PROJECT: Skye Canyon Parcel 2.16

SUBMITTAL: 2nd Submittal

CITY OF LAS VEGAS		DATE: Revised
INTER-OFFICE MEMORANDUM		January 23, 2017
TO: Land Development Services Department of Building & Safety		FROM: Albert Sung, P.E. Flood Control Project Engineer Department of Public Works
SUBJECT:	Drainage Study for: Skye Canyon Parcel 2.16	
Cross Streets:	NWC of Egan Crest Dr. & Eagle Canyon Av.	COPIES TO: Slater Hanifan Group
File Number:	F:\Depot\DSMemos\DS4842B-Rev.doc	Section 12, LLC / Ninety Five Mangt.
Parcel Number:	126-12-000-001	Bart Anderson, P.E., DevCo
Zoning Action:	TMP-65809	CCRFC
FEMA Flood Zone	YES	NO X
Proposed Storm Drain	YES	NO X

This letter is submitted in response to comments contained in the November 29, 2016 comment letter received from City of Las Vegas (CLV) regarding the above referenced project. A copy of the CLV conditional approval letter is included in Appendix A for reference. The following comments have been individually addressed:

G-1
SHEET 4 OF 10
CLV#

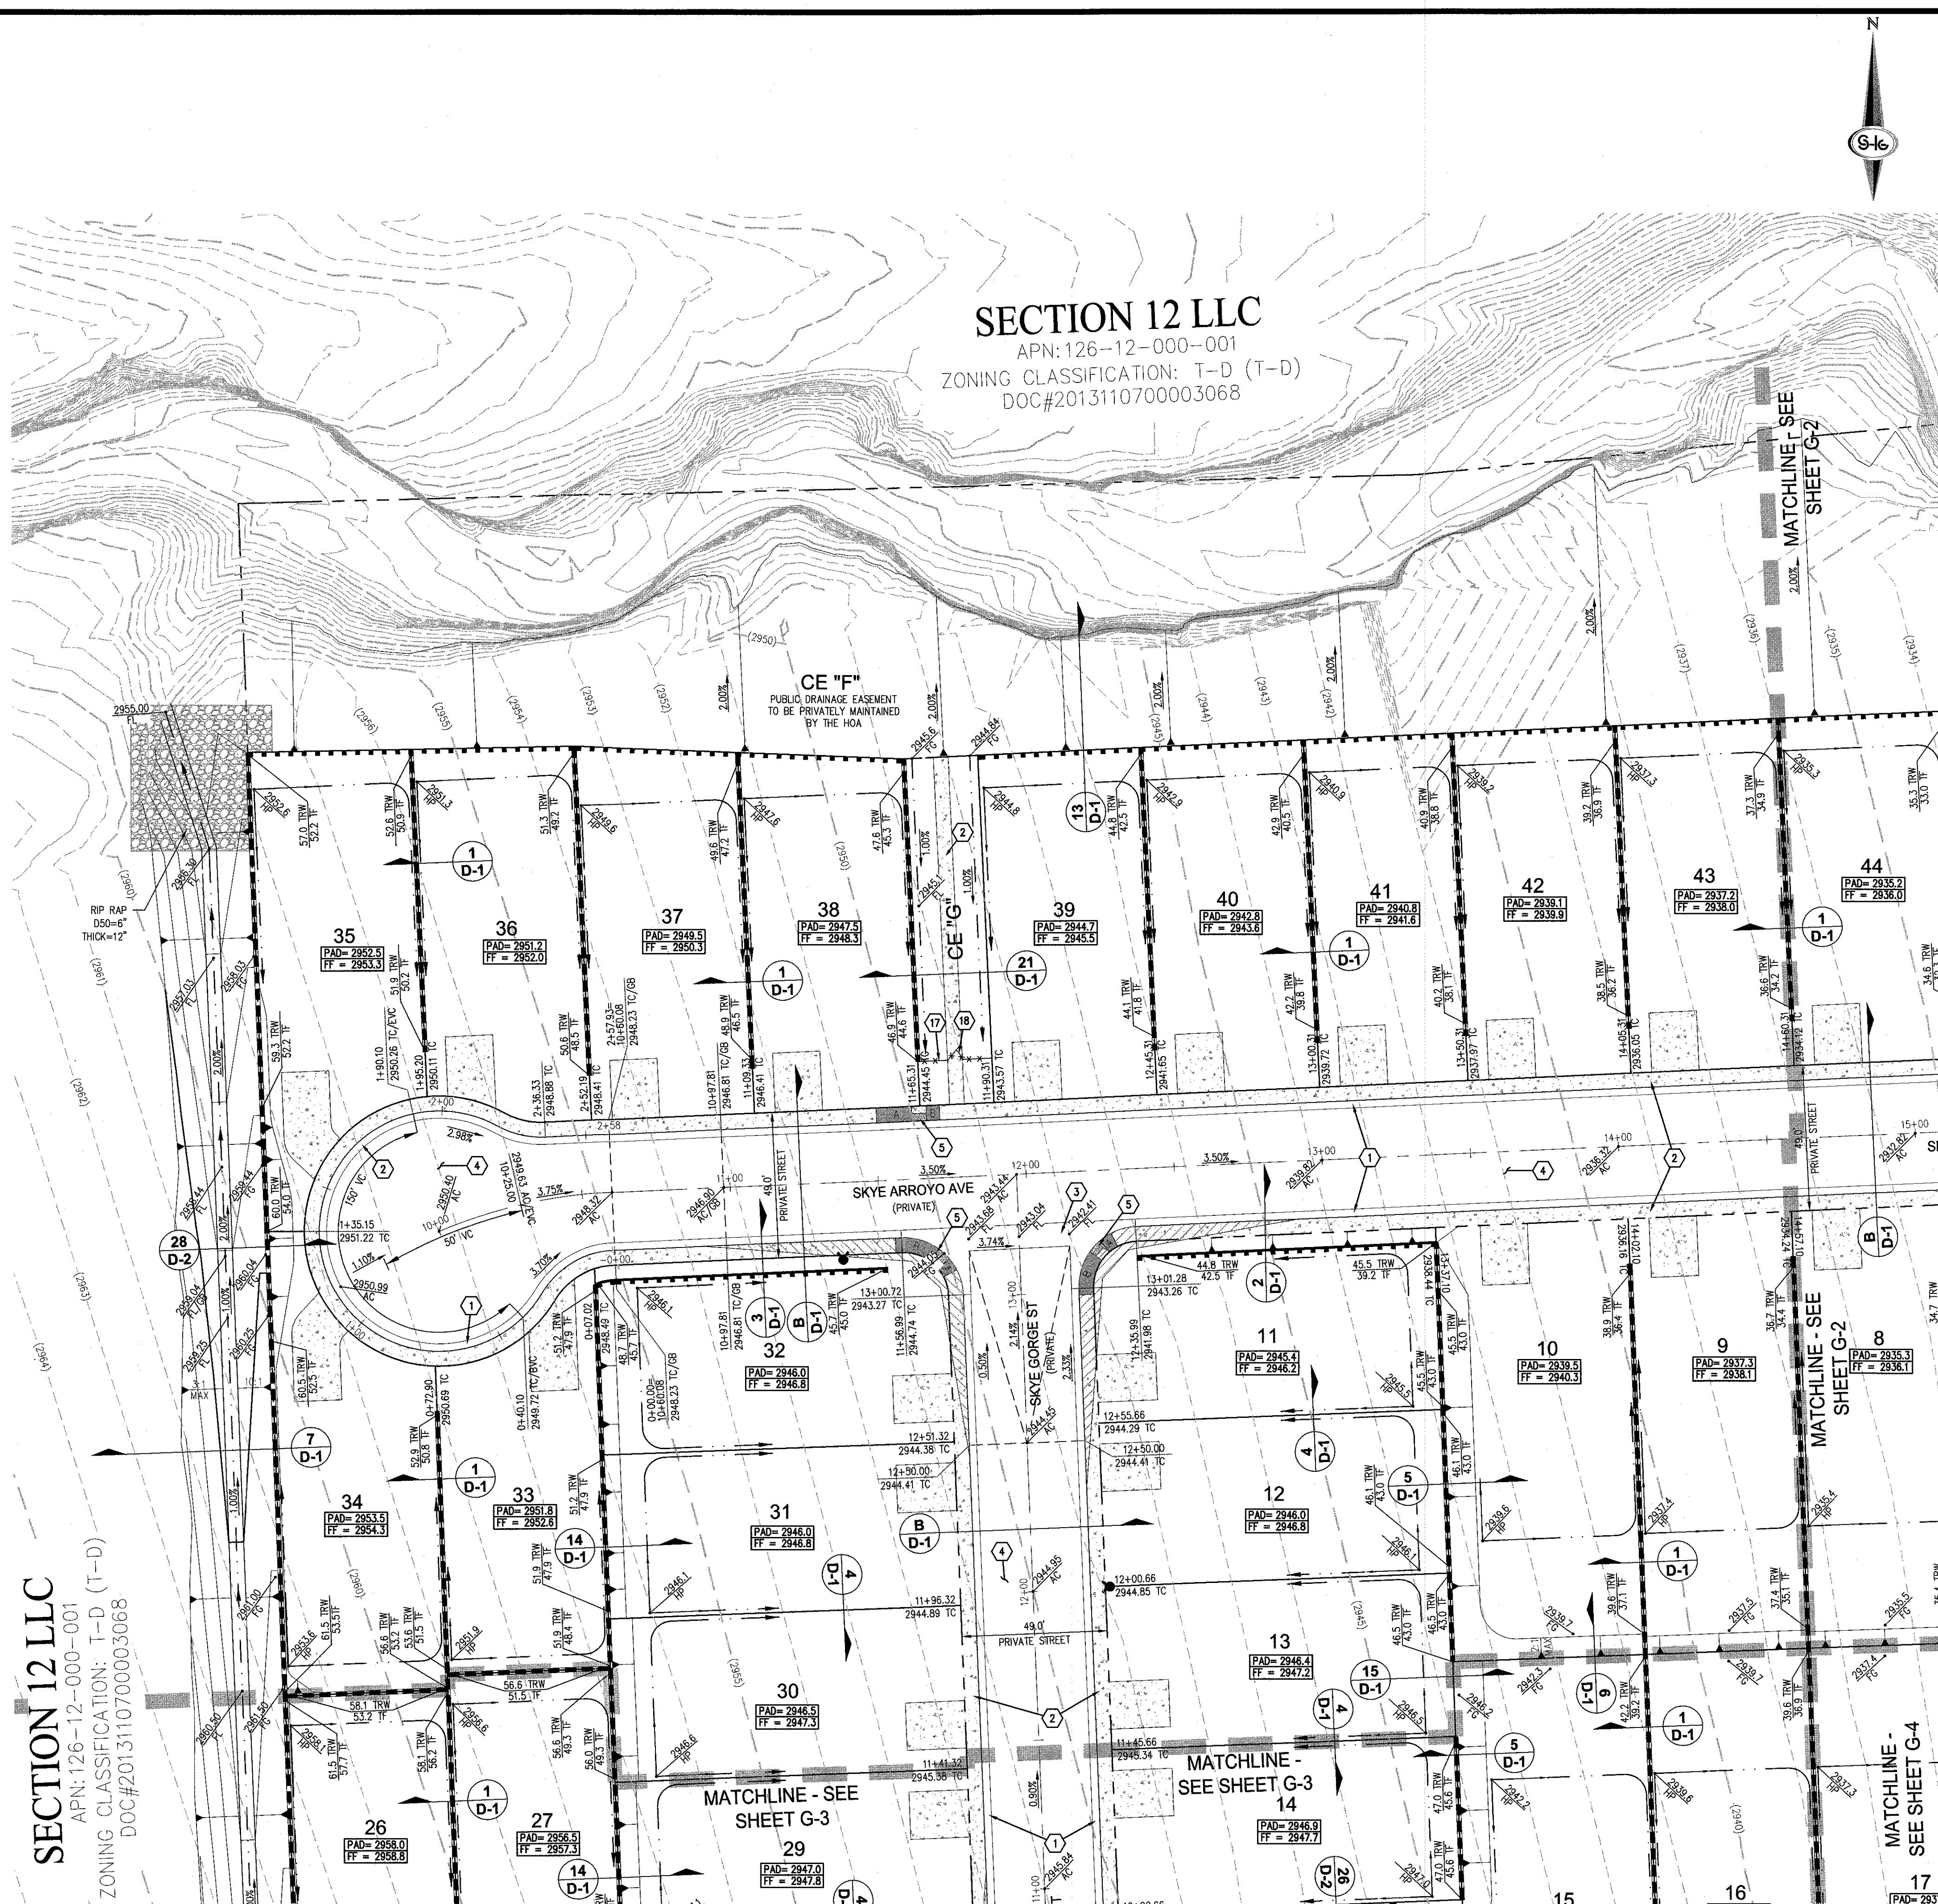
9. **Comment:** *Grading Plan I (Sheet G-1): As discussed in Comment #8 above, revise the cul-de-sac of Skye Arroyo Avenue to provide a public drainage easement to accept flow from the offsite basin to the west.*

16. **Comment:** *The engineer must provide a table on the grading plans that shows a quantity estimate of all drainage improvements within Public Drainage Easements. All drainage improvements within Public Drainage Easements must be bonded and inspected.*

Response: The proposed design was not revised and therefore a drainage easement is not provided. Runoff from WL4A will continue to be conveyed north along the western boundary of Parcel 2.16 via drainage ditch to the existing Arroyo. Rip-rap is proposed at the outlet of the drainage ditch to minimize the effects of erosion potential caused by ground disturbance. The drainage ditch was revised to conform to the mass grading contours shown within the Phase 2 Infrastructure Study. Note that the channel geometry and flowline elevations remain consistent with the original submittal. Refer to Response to Comment No. 8 for a more detailed discussion on why the proposed design was not revised.

Response: Sheet G-1 is now showing the drainage quantities.

NINETY FIVE MANAGEMENT, LLC SKYE CANYON PARCEL 2.16 GRADING PLAN IV

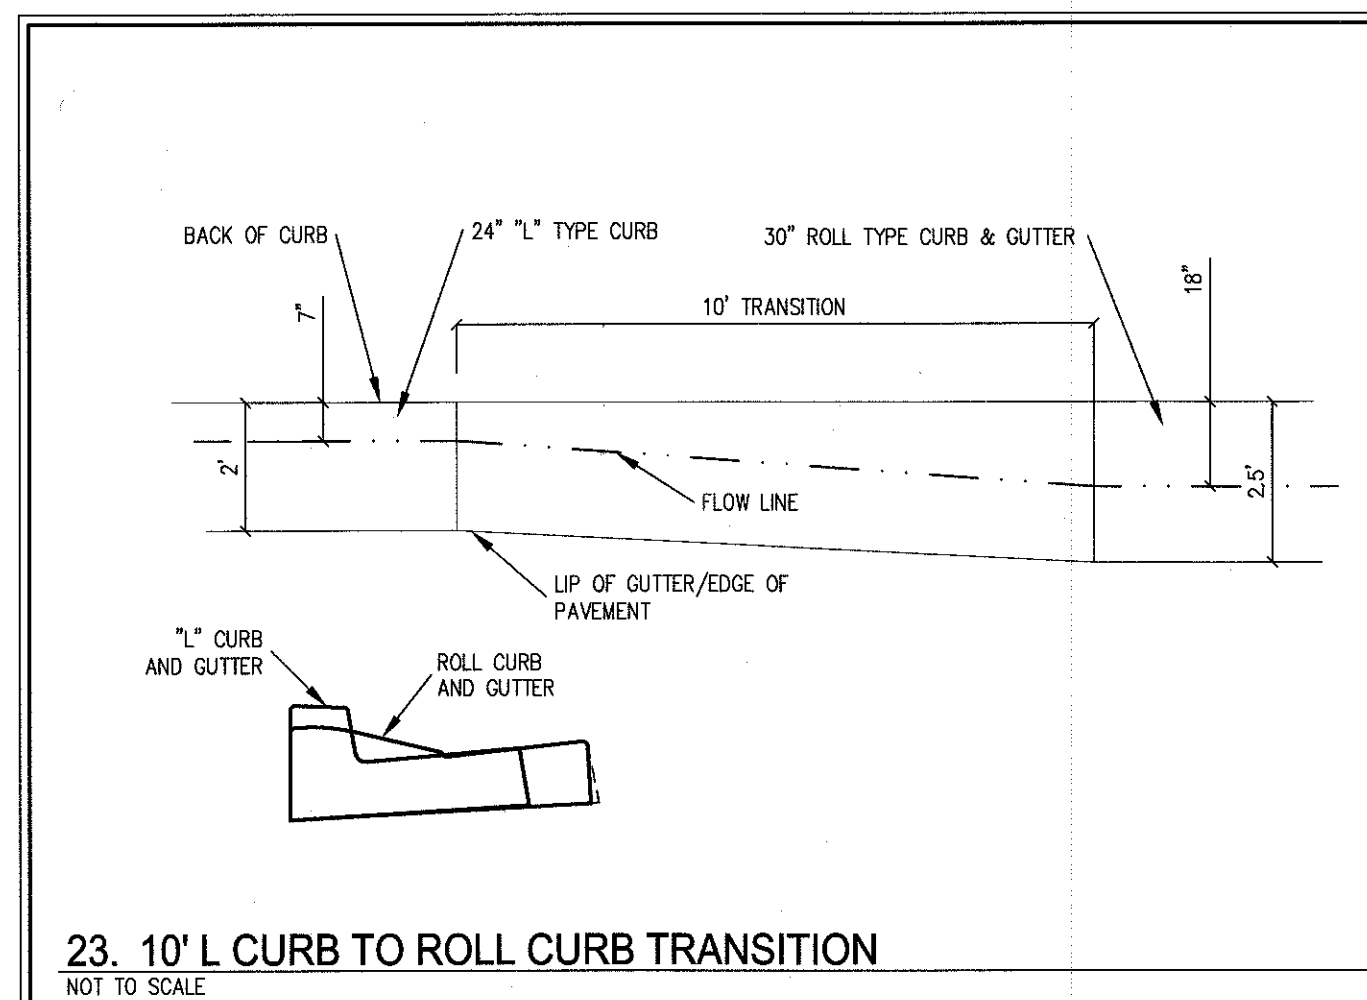
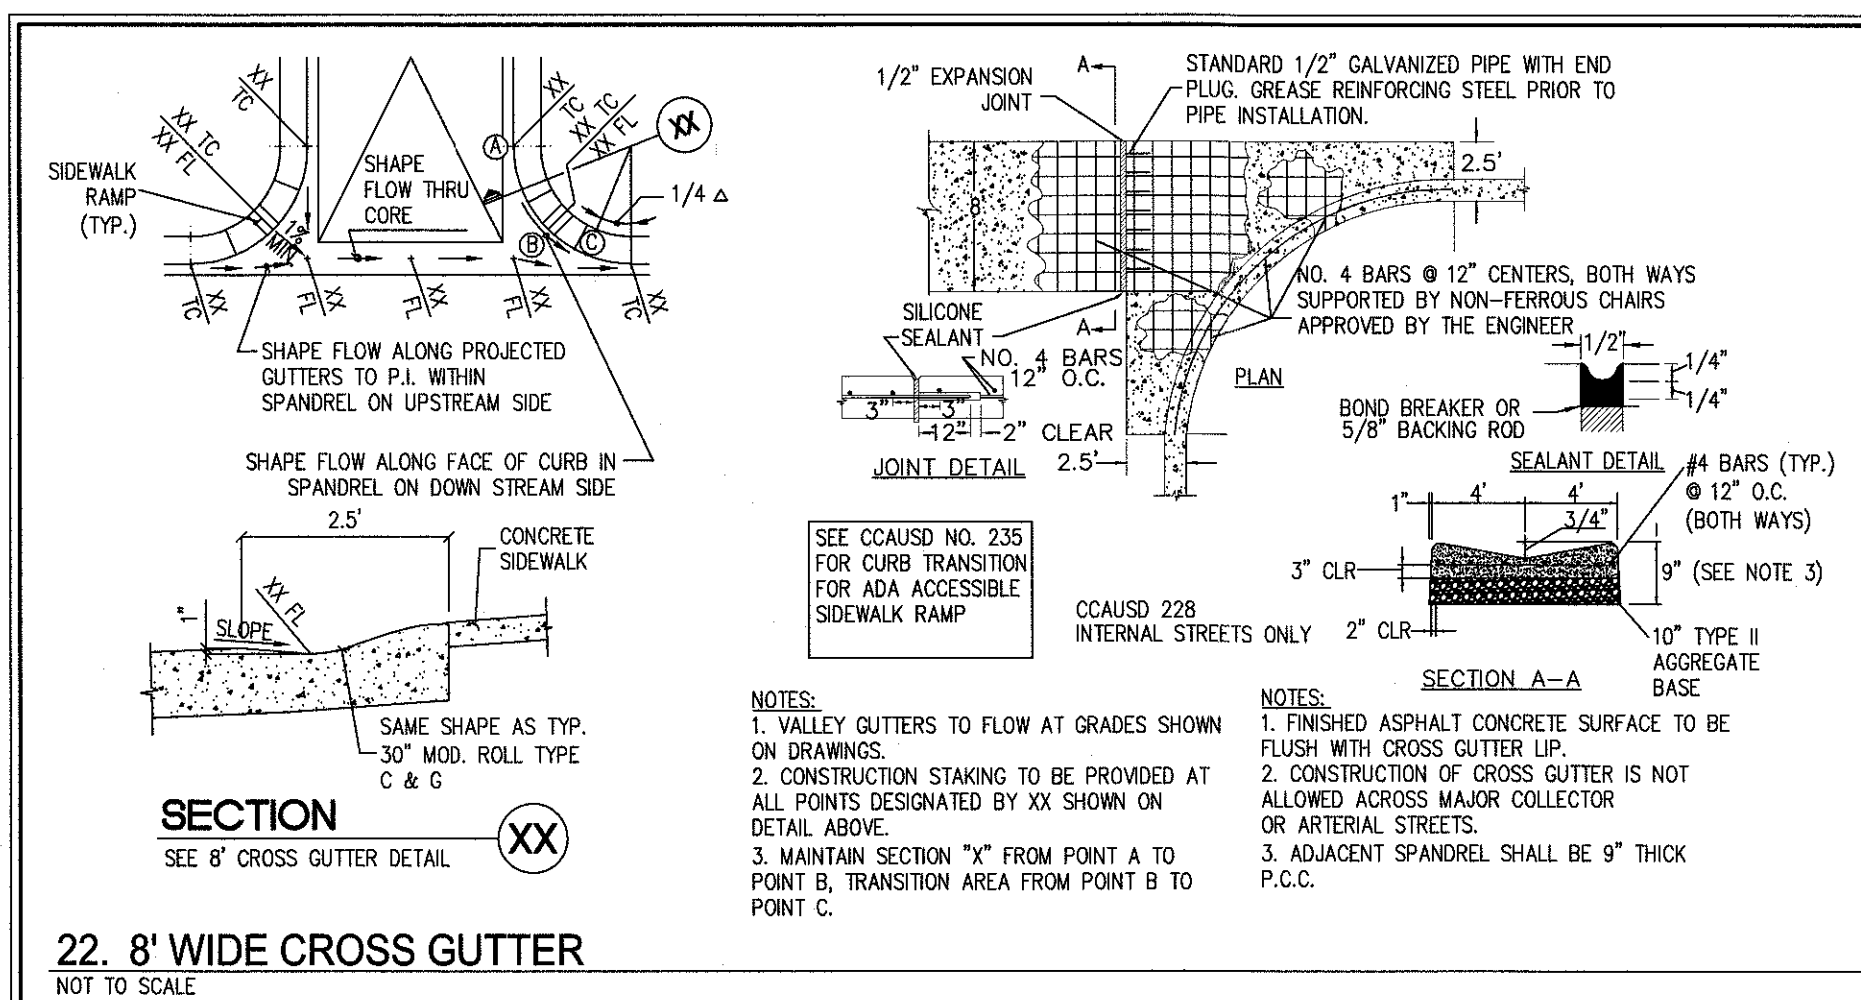
It appears that Parcel 2.16 will be developed after Parcel 2.15 adjacent to the east of Egan Crest Drive. Show developed condition of Parcel 2.15 on Sheet G-2 and Sheet G-4.

Future Skye Canyon Parcel 2.15 is now shown on the grading sheets as bracketed improvements for spatial reference. It is not known which development will be constructed first, and the order of development between Parcel 2.16 and 2.15 does not have any impact on this design. See revised grading provided in Appendix F.
